802.1ah/D3.8 comments MAC_Operational

Maarten Vissers
November 2007

MAC_Enabled and MAC_Operational

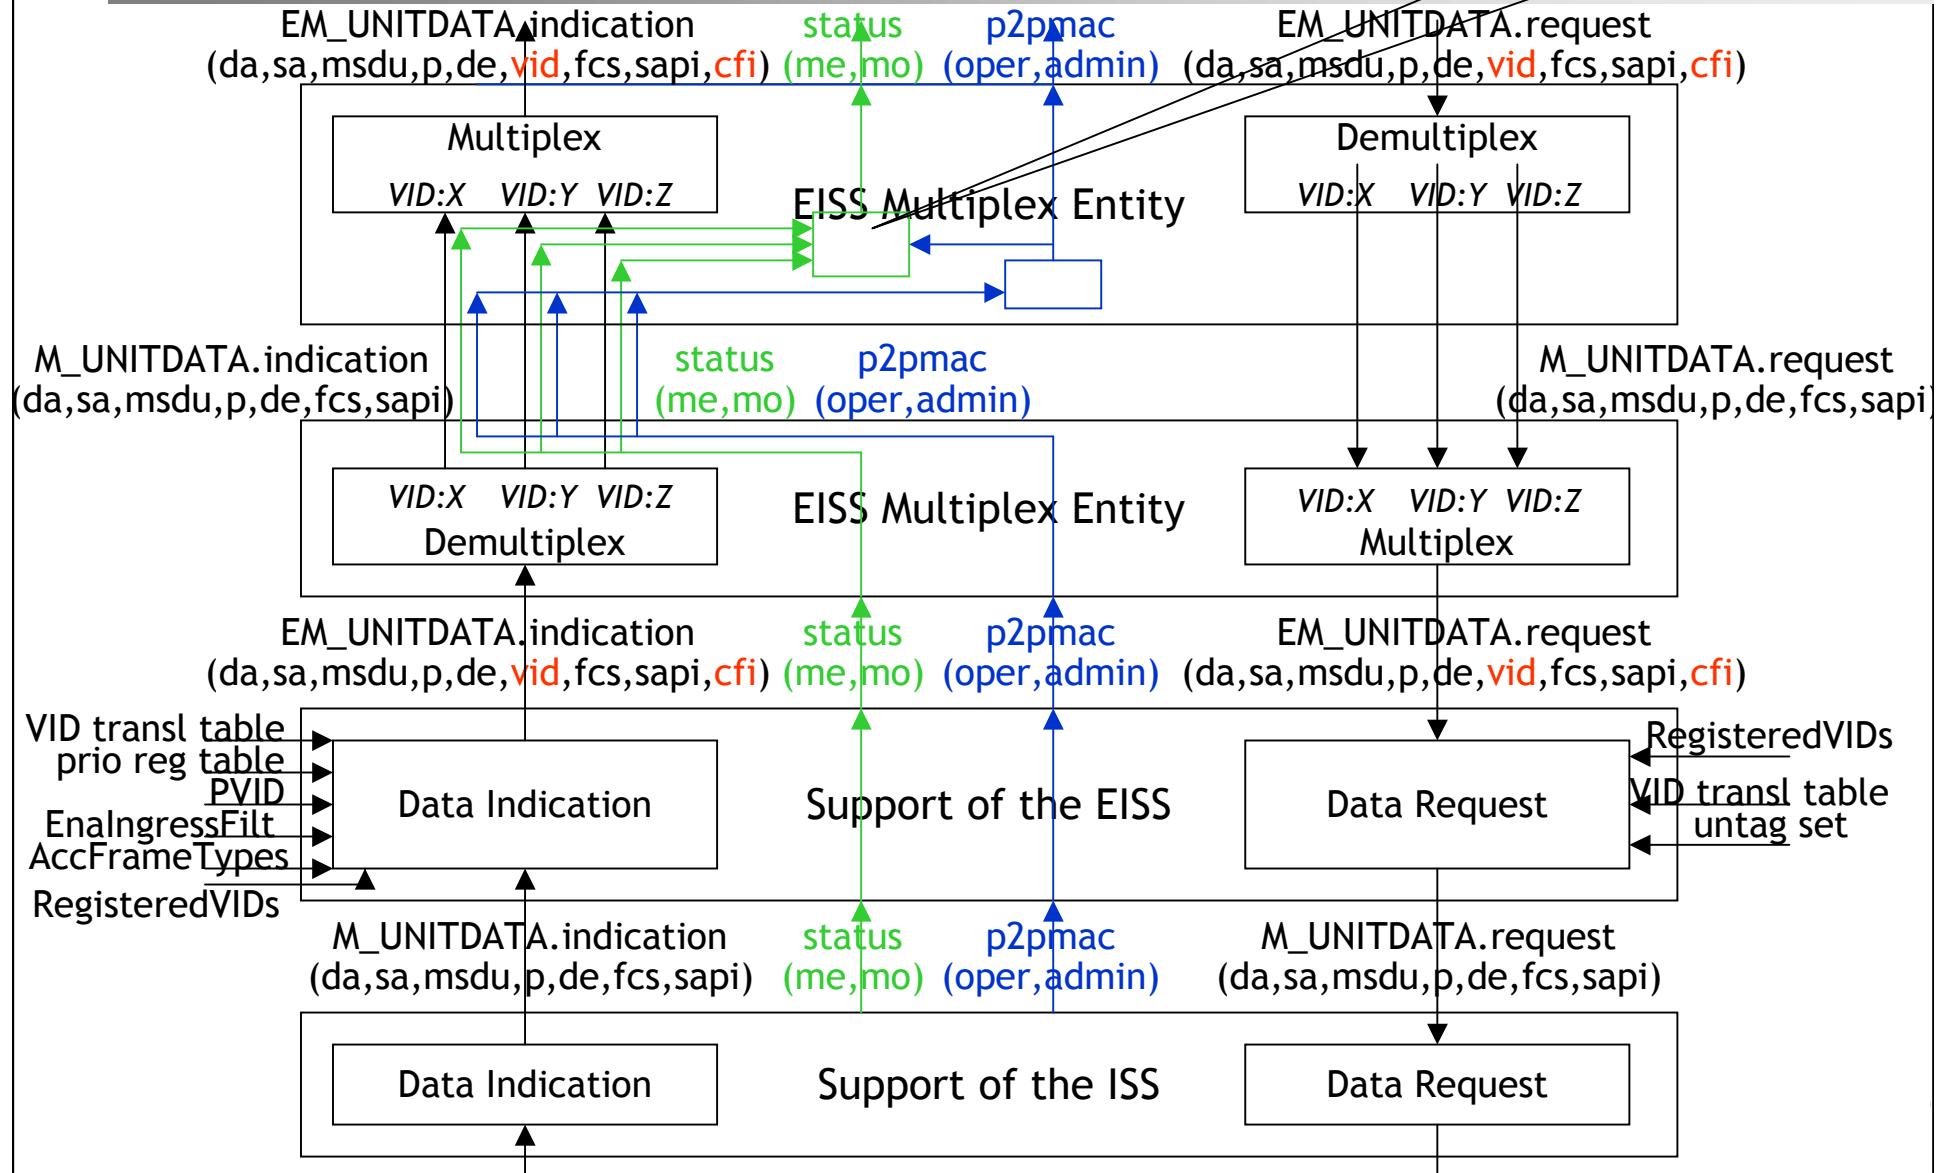
combining the individual
MAC_Operational signals
disables alarm
suppression capability
